Planning Direction Pty. Ltd.
Town Planning & Development Services

**Development Application(s)
 59 Cudgegong Road Rouse Hill Site 1
 DA SPP-17- 400007**

I refer to the above matter that was considered by the Sydney Central Planning Panel on 24th April 2019 at which time the determination of the application was deferred pending the submission of amended plans/information that:

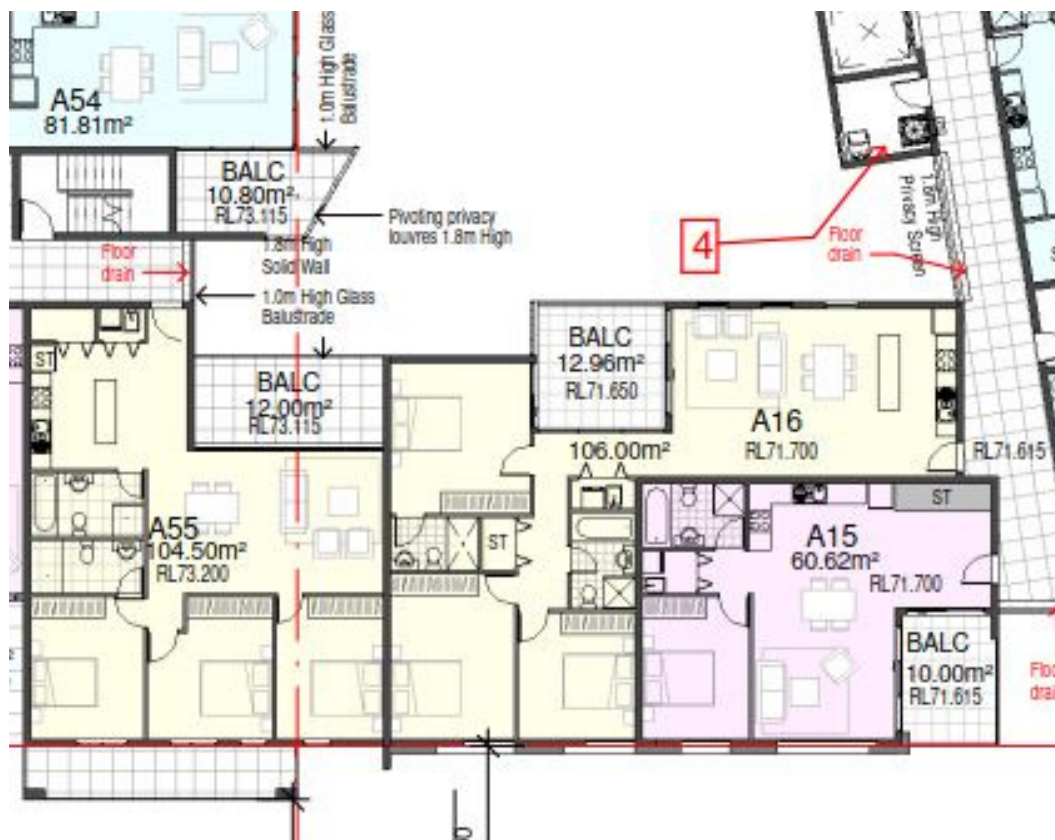
The amended plans increase the quantum of deep soil on the site through the provision of additional areas in the north western corner of the site, the south western corner of the site, midway along the

northern street boundary (adjacent to the pedestrian entry), and increasing the size of the deep soil area that is centrally located between blocks A and B . These areas have a minimum dimension of 6m and are able to accommodate large canopy trees. This has resulted in a reduction in the amount of on-site car parking however the proposal remains compliant with the car parking requirements under the governing planning regime.

1. Deep soil zones with a minimum dimension of 6m in any direction: 889.54sqm or 10.48% of the site area
2. Additional deep soil with a dimension of less than 6m: 403.42 sqm or 4.75% of the site area
3. Total deep soil (sum of 1 and 2): 1292.96sqm or 15.23% of the site area
4. Planting on structures (soil depth of a minimum 1000mm): 561.56sqm or 6.61% of the site area
5. Total Deep soil areas (sum of 1, 2 and 4): 1921.28sqm or 22.63% of the site area

Having regard to the above the Panel can be satisfied that the proposed buildings will sit in a well landscaped setting. The ‘quantum’ of deep soil has been increased as requested and complies with the ADG guidelines. The natural deep soil areas are supplemented by additional planting on structures. Importantly the proposed landscaping provides a high quality environment having particular regard to the streetscapes and the amenity of internal areas.

Originally proposed balcony relationship

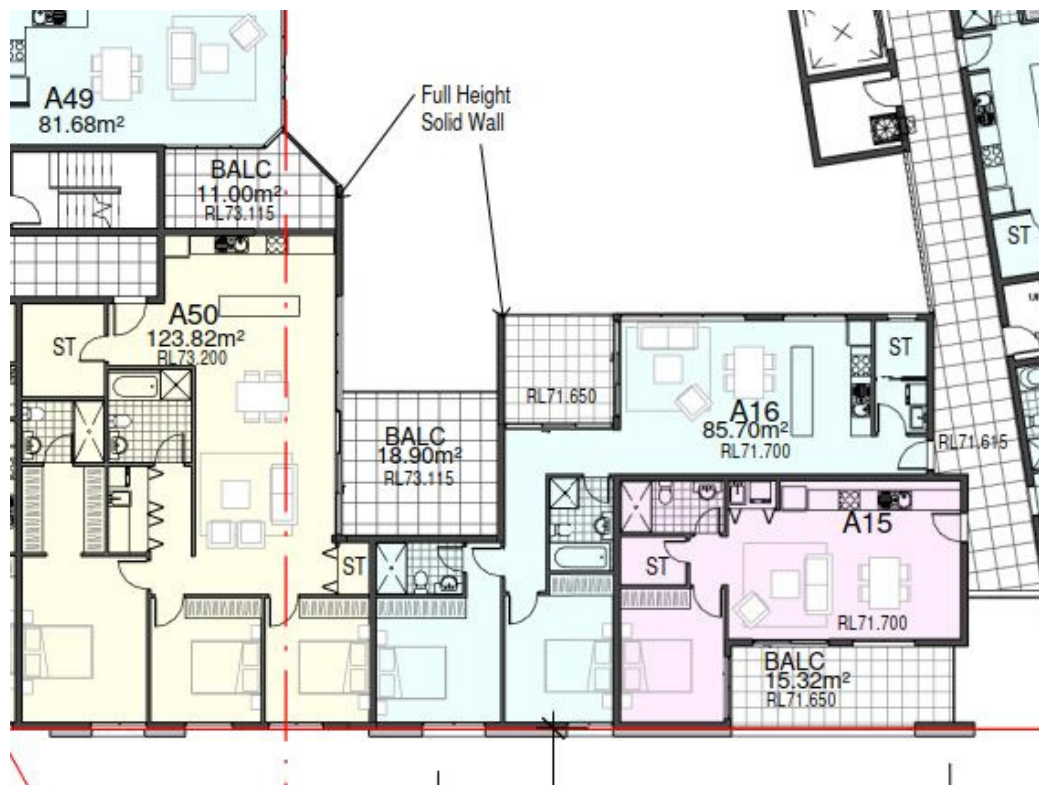
The plans have been amended to improve the spatial relationship between balconies; the separation between 'building A' and 'building B' has been increased.

There have also been modifications to the unit/balcony layouts to resolve the privacy concerns identified by the Panel; these modifications have also improved solar access.

The above has resulted in a reduction in the unit yield from the proposed 170 apartments to 163 apartments. The overall site FSR is 1.64:1 being well under the permitted 1.75:1.
